**MEETING OF THE DESIGN REVIEW BOARD
MORRIS N. BROAD COMMUNITY CENTER
1175 95TH STREET
BAY HARBOR ISLANDS, FL 33154**

REVISION # 1 REVISION DATE: 07/18/23

Subject: Site Development Plan Application - Revision
Proposed New 9 DU Multifamily Residential Complex
Revisions to Approved Site Development Plan
1055 93rd Street
Bay Harbor Islands Acct. No. SPR22-000026
MMPA Acct. No. 01-0702-1144

Revision to Approved Planning and Zoning Board Submission

Sheet A-21b, Exterior Elevation - NORTH

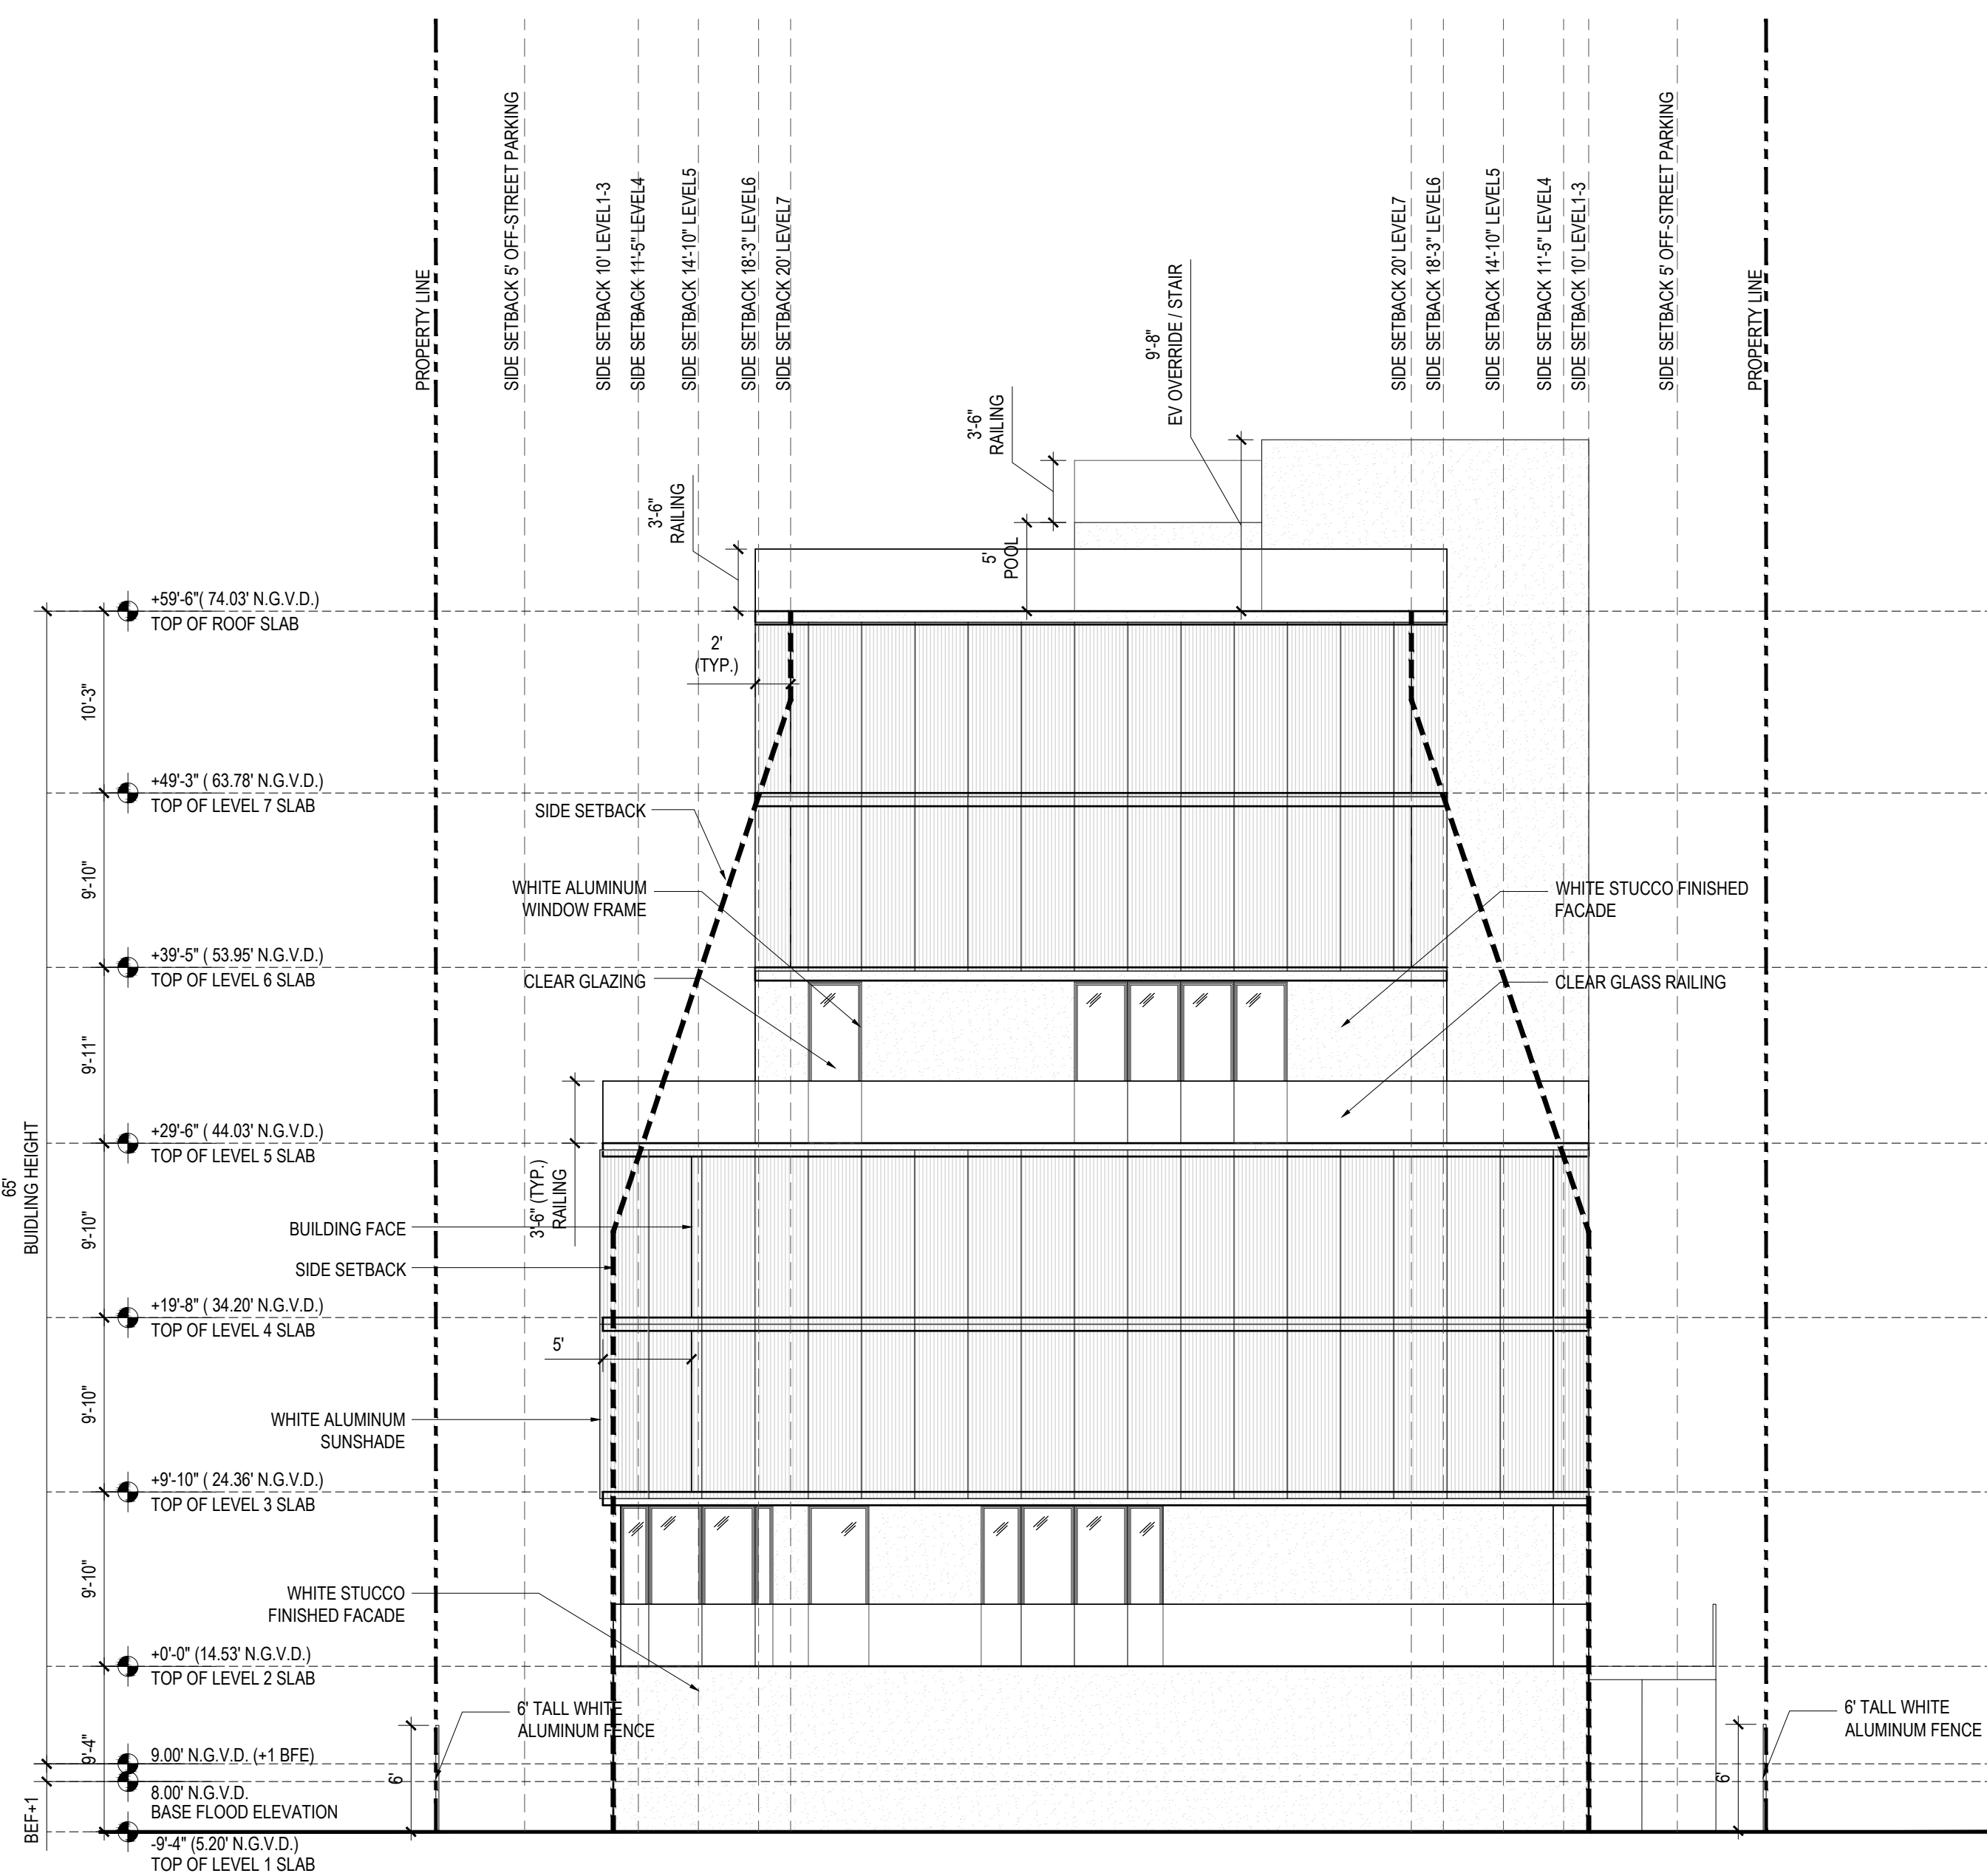
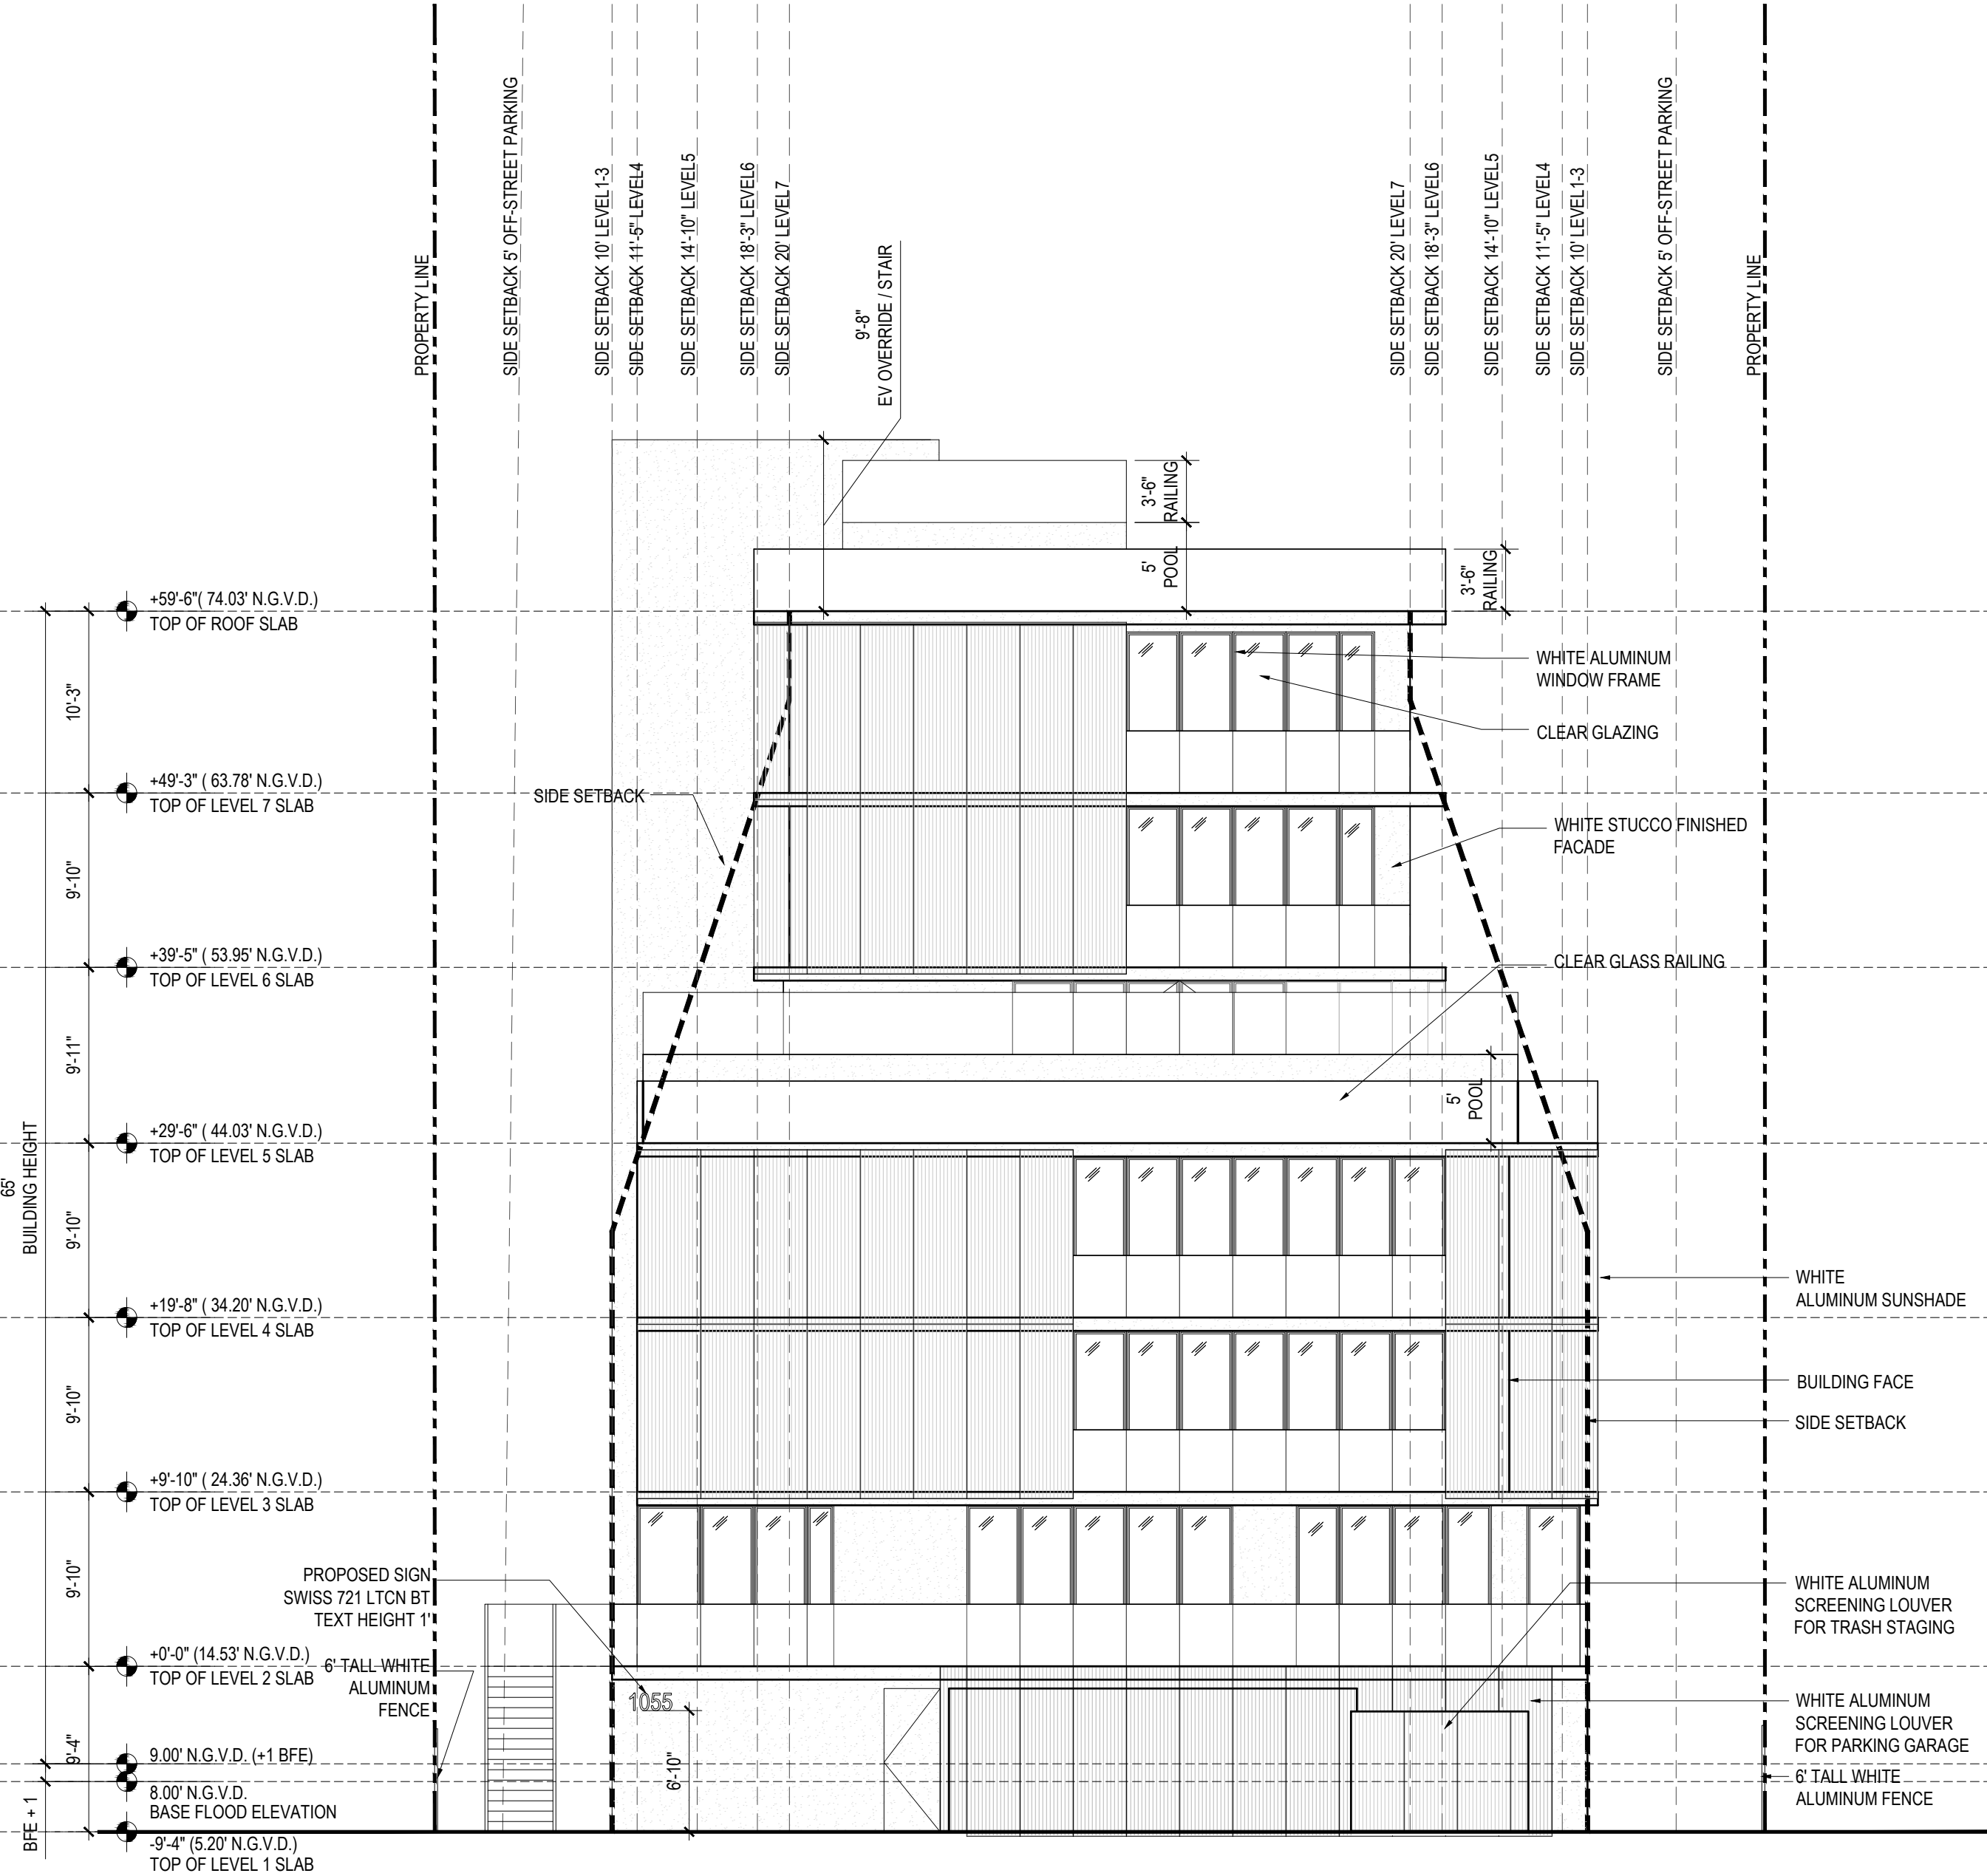
1. Modifications to the North Elevation to remove the north facing balconies and associated louvers on Levels 3 and 4 and to reduce the balcony on Level 5 due to the proximity to the FPL power lines that are running along the rear property line
2. Modifications to the exterior window/door placements and sizes due to changes to the unit layouts and coordination with Structural
